# COUNTY OF SONOMA

Description: RAIL C/ BRIDGE OVER MILLER CREEK - BRIDGE #2

DOCUMENT: DRAINAGE REVIEW - STORAGE POND \_\_\_ GRADING \_\_\_ HYDROLOGY \_\_\_ X \_\_\_  
 PROJECT NUMBER \_B-143159 BY \_B.ROBERTS\_ DATE 8/28/96

## MILLER BRIDGES # 1 & 2 HYDRAULICS

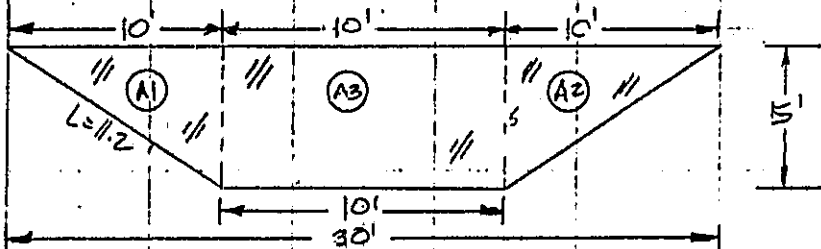
1. Water shed area = 368ac. Engineer used the Rational Method with a 100 yr storm freq, 600 CFS. For an open channel desigr.
2. Hydro/Hydra Calculations were checked . OK

BRIDGE #2: 8-143159

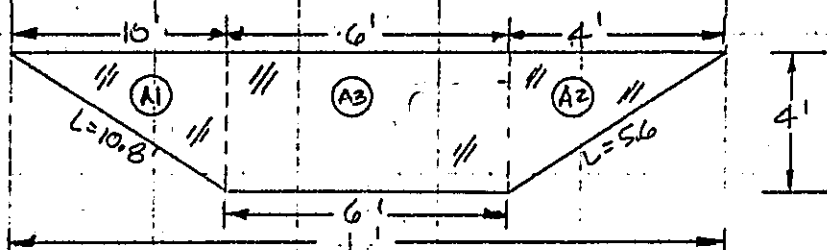
1. Water shed area = 314ac. Engineer used the Rational Method with a 100 yr storm freq, 410 CFS. For an open channel design.
2. Hydro/Hydra Calculations were checked . O.K
